Recall Bulletin

PRODUCT SAFETY RECALL

SUBJECT: Lower Control Arm Ball Joint Retaining Bolt Loose

MODELS: 2014 Chevrolet Spark

2327521

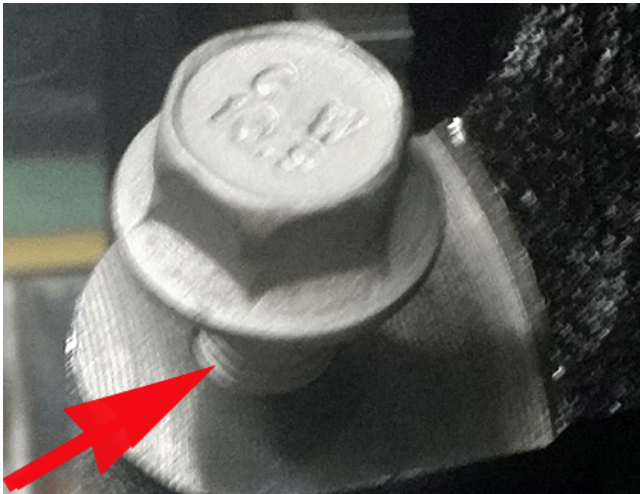
2. Locate the left and right lower control arm ball joint to steering knuckle retaining bolts (1).

- 3. If the bolt is backed out of the steering knuckle, inspect the bolts for damage. If the bolt appears to have any type of damage, remove and replace the bolt. Torque the bolt to specification on all vehicles whether the bolt appears loose or not.

- 4. Using a torque wrench, tighten the left and right lower control arm ball joint to steering knuckle retaining bolts. Tighten to **65 N-m (48 lb ft)**.
- 5. Lower the vehicle.
